Access Compliance Report

Public Rights-of-Way

(Curb Ramps)

Intersection ID: 19986	Main Street: ARCHDALE_DR	Cross Street: SOUTH_BV	Location: NE
ADA ID: 10E80485DE1E	Ramp Type: Perp	Initial Pass/Fail: Fail	Overall Compliance: No
		Severity Score: 22.5

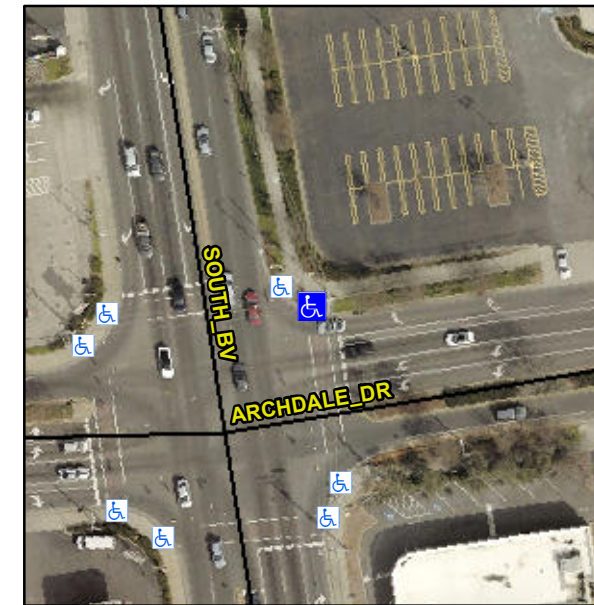
Not Found, R304.5.1, R304.2.2, R304.5.3

Compliance	Description	Data	Compliance	Description	Data
N/A	Ramp Length (in)	98.0	No	Ramp Slope (%)	8.8
No	Ramp Width (in)	46.5	No	Ramp XSlope (%)	2.6
N/A	Flare Type LT	N/A	N/A	Flare Type RT	N/A
N/A	Flare Slope LT (%)	N/A	N/A	Flare Slope RT (%)	N/A
N/A	Flare Traversable LT?	N/A	N/A	Flare Traversable RT?	N/A
N/A	Landing Length (in)	N/A	N/A	DWS Provided?	N/A
N/A	Landing Width (in)	N/A	N/A	DWS Contrast?	N/A
N/A	Landing Slope (%)	N/A	N/A	DWS Length (in)	N/A
N/A	Landing X Slope (%)	N/A	N/A	DWS Full Width?	N/A
N/A	Landing Curb? (Y/N)	N/A	N/A	DWS Offset (in)	N/A
N/A	Shared Landing?	N/A			
N/A	Gutter Ponding?	N/A	N/A	Gutter Slope (%)	N/A
N/A	Gutter Lip Ht (in)	N/A	N/A	Gutter X Slope (%)	N/A
N/A	Painted X Walk1?	Yes	N/A	Painted X Walk2?	N/A
	X Walk 1 Direction	To S		X Walk 2 Direction	N/A
N/A	X Walk 1 Width (in)	112.0	N/A	X Walk 2 Width (in)	N/A
	X Walk 1 Slope (%)	1.2		X Walk 2 Slope (%)	N/A
	X Walk 1 X Slope (%)	1.1		X Walk 2 X Slope (%)	N/A

Remove & Replace Entire Ramp.
